CERTIFICATE OF APPROPRIATENESS

Property: 1801 Crockett St, Lot 7, Block 305, Shearn Subdivision. The property includes a historic 1,400 square foot, one-story wood frame single-family residence and a detached garage apartment situated on a 5,000 square foot (50' x 100') corner lot.

Proposal: Alteration – Windows/Porch

WEST SIDE ELEVATION

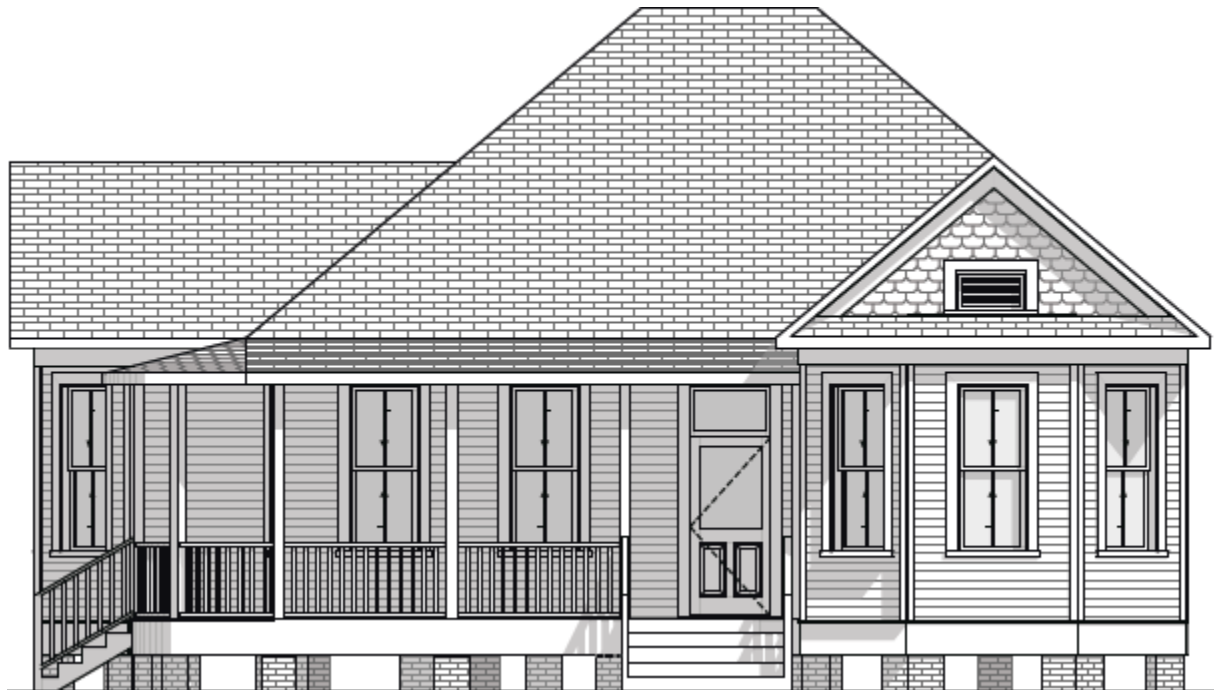
| <input type="checkbox"/> | <input checked="" type="checkbox"/> | <input type="checkbox"/> | (1) The proposed activity must retain and preserve the historical character of the property; <i>Altering the original fenestration on the west elevation does not retain or preserve the historical character of the property because it disrupts the historic solid-to-void pattern.</i> |
| <input type="checkbox"/> | <input checked="" type="checkbox"/> | <input type="checkbox"/> | (3) The proposed activity must recognize the building, structure, object or site as a product of its own time and avoid alterations that seek to create an earlier or later appearance; <i>Creating new window openings on the west elevation alters the historic fenestration which creates a later appearance.</i> |
| <input type="checkbox"/> | <input checked="" type="checkbox"/> | <input type="checkbox"/> | (4) The proposed activity must preserve the distinguishing qualities or character of the building, structure, object or site and its environment; <i>Altering the original fenestration and cutting new window openings on the west elevation does not preserve the character of the building.</i> |
| <input type="checkbox"/> | <input checked="" type="checkbox"/> | <input type="checkbox"/> | (9) The proposed design for any exterior alterations or addition must not destroy significant historical, architectural, archaeological or cultural material, including but not limited to siding, windows, doors and porch elements; <i>Altering the fenestration and creating new window openings on the west elevation will require extensive reframing and removal of siding, resulting in a loss of historical and architectural material.</i> |
| <input type="checkbox"/> | <input checked="" type="checkbox"/> | <input type="checkbox"/> | (10) The proposed alteration or addition must be compatible with the massing, size, scale material and character of the property and the context area; and <i>Altering the original fenestration on the west elevation disrupts the existing solid-to-void pattern, and is not compatible with the character of the property.</i> |

Original window opening

Bottom sash to be relocated

Relocated window

Recommendation: Approval with conditions: On the west elevation: (1) Retain the historic 2/2 wood windows in their existing locations; and (2) Install one 2/2 wood window in the historic opening.

If the applicant were to retain the two 2/2 windows in their existing location and install one 2/2 window in the historic opening, staff believes the proposal would satisfy Criteria 1, 3, 4, 9, and 10.
